**From:** Manoj Nathoo (AT)  
**Sent:** Wednesday, 30 April 2025 9:38 am  
**To:** Siobhan O'Donovan (AT)  
**Subject:** FW: Canada/East St sketch

**From:** Putri Kusumawardhani (AT) <Putri.Kusumawardhani@at.govt.nz>  
**Sent:** Tuesday, 11 March 2025 3:04 pm  
**To:** Sophia Wang (AT) <Sophia.Wang@at.govt.nz>; Vaughn Scott (AT) <Vaughn.Scott@at.govt.nz>; Mathew Rudez (AT) <Mathew.Rudez@at.govt.nz>  
**Cc:** Manoj Nathoo (AT) <Manoj.Nathoo@at.govt.nz>; Jason Budd (AT) <Jason.Budd@at.govt.nz>; Suresh Patel (AT) <Suresh.Patel@at.govt.nz>; s7(2)(a) Privacy <s7(2)(a) Privacy@beca.com>  
**Subject:** RE: Canada/East St sketch

Following our meeting yesterday, this email is to confirm the preferred approach for our design update. I have attached a bluebeam markup (to the best of my ability) to show what was discussed yesterday. There may be some errors and/or things not updated but I've designed a realigned pedestrian/cycle crossing to be a safer 90degree alignment, with both directions of traffic (the previous was aligned 90degrees to the westbound approach). I have also provided two options for cyclist connection between East St and Canada St:

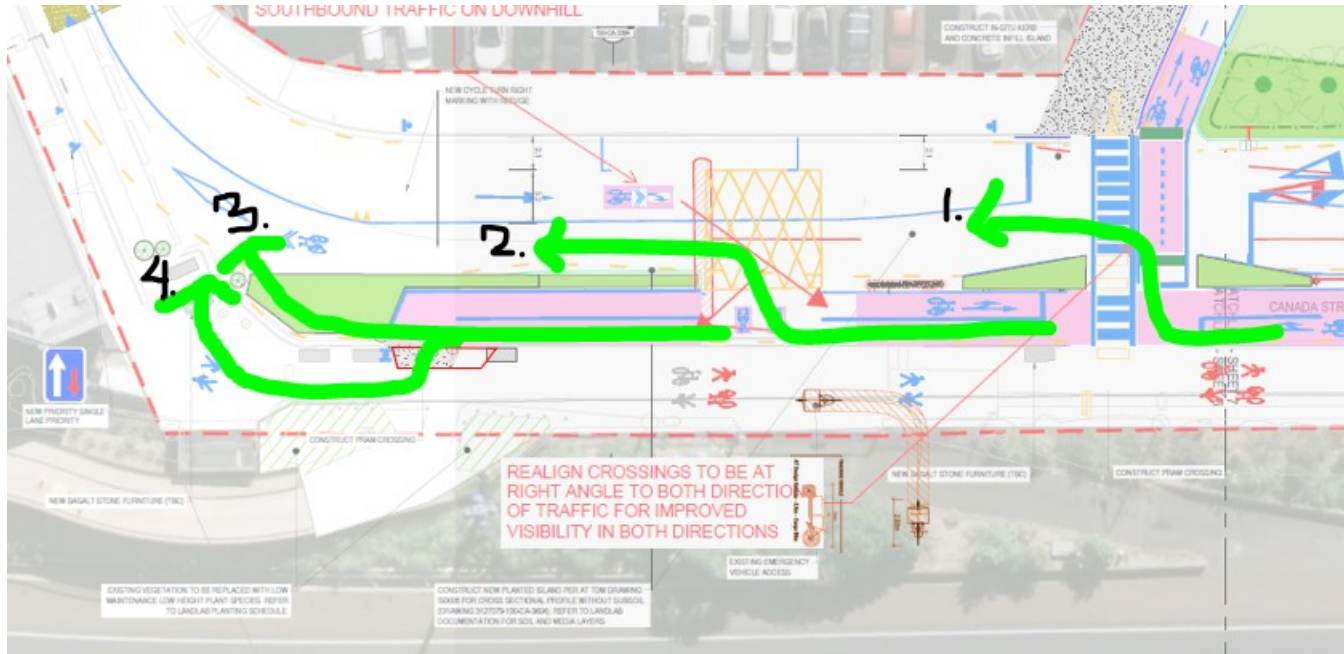
It seems to me that the challenge isn't just about the movement coming from Lightpath (left turning), but also the westbound cyclist coming out from two-way cycleway to the sharrow environment.

How do you envision people on bikes navigating this area? Specifically, do you expect them to:

1. Go through the paired/dual crossing?
2. Go through the gap on VC access to merge with westbound traffic to sharrow East St?
3. Go through the cycle ramp, via shared path and back down via cycle ramp to Sharrow East St?
4. Go through the kerb build out (creating a gap for one-way exit to sharrow)?

If route #4, as you highlighted below, is the preferred option, it will necessitate a new cycle ramp (adjacent to number 4), clearance space to basal street furniture, and checking for the turning radius for the left-turning people on bikes from Lightpath. In my opinion, I would recommend keeping the path as a footpath and creating a gap for route 3. This option seems clearer and avoids any unnecessary levelling up and down movements for people on bikes.

Thanks for the valuable inputs. For the item #1, would you accept cyclists coming from the light path to join a shared use space with pedestrians as shown in red in the snip below? The circled area is currently a shared path area, so we can retain the current road markings and cyclists can also use the existing ramp down to join the general traffic on East St. Item #2 and #3 will be addressed by design updates.

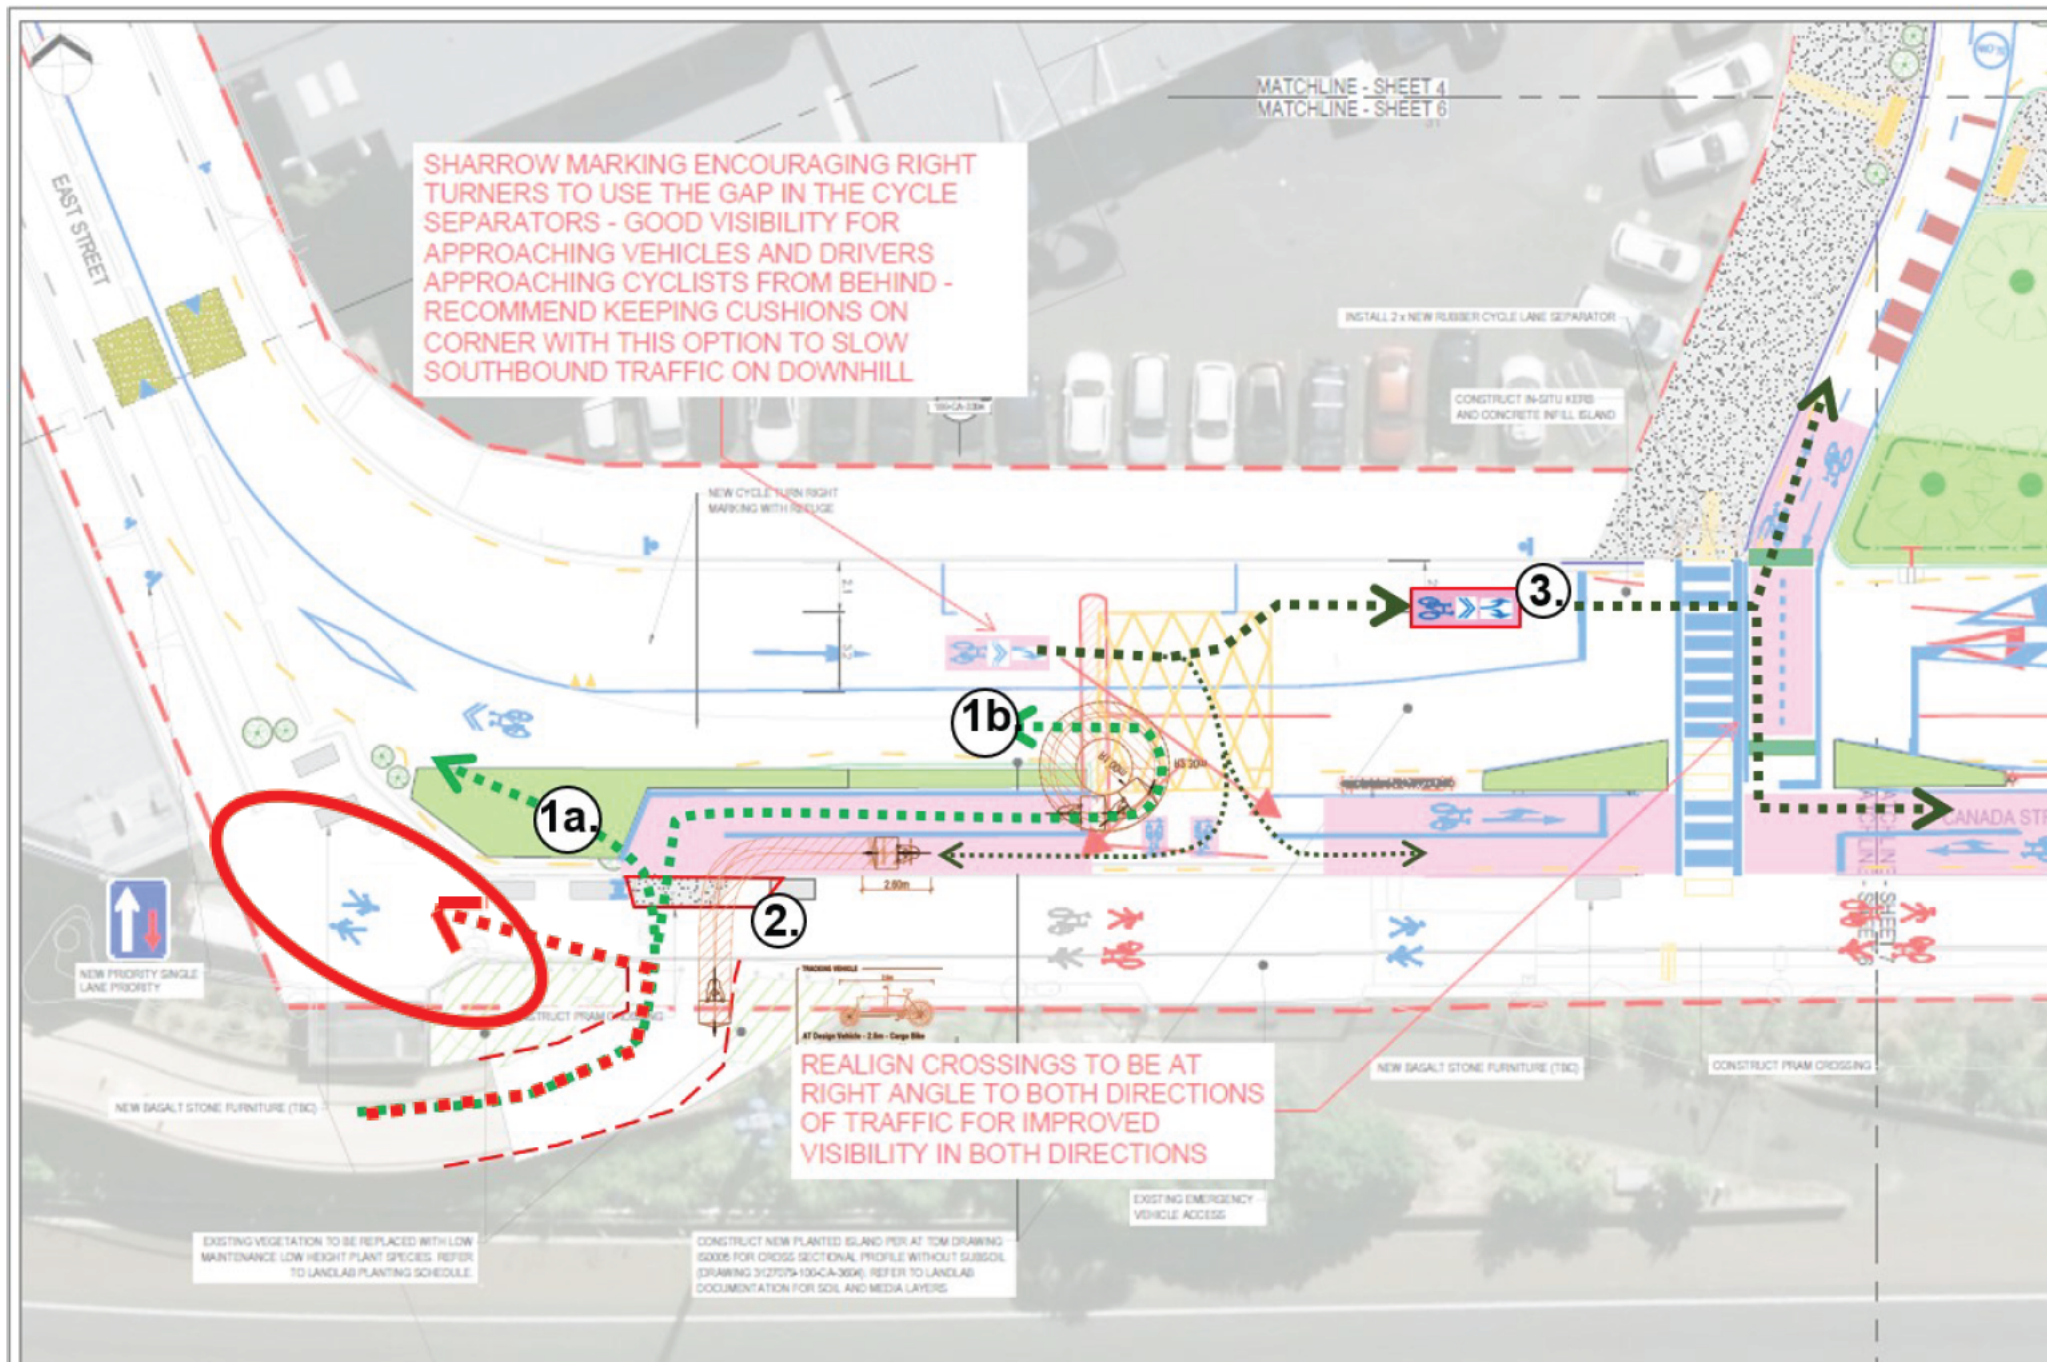
Apologies for the delay in my response. I've given a lot of thought to the expected movement concerning the updated design layout on Canada St/East St.

From my technical perspective, I think **Option 1** is clearer. However, I believe there is a slight refinement needed specifically regarding radius turning, for Option 1.

1. People on bikes coming out from Lightpath should be able to turning left (1a.) rather than being expected to come out between the separator gap (intended for maintenance access). The turning manoeuvre (1b.) as currently designed seems quite challenging. Please see the tracking example attached for a clearer illustration.
2. Cycle ramp connecting Light Path to proposed (separated) cycleway will need to be widen and the proposed bench will need to be shifted outside the turning manoeuvre. Additionally, the cycle ramp should have a gentle gradient to assist the turning movement for cyclists. This will make the transition smoother and safer.
3. Additional sharrow marking with arrow is needed at the termination point of the sharrow to the separated cycleway to guide cyclists effectively.
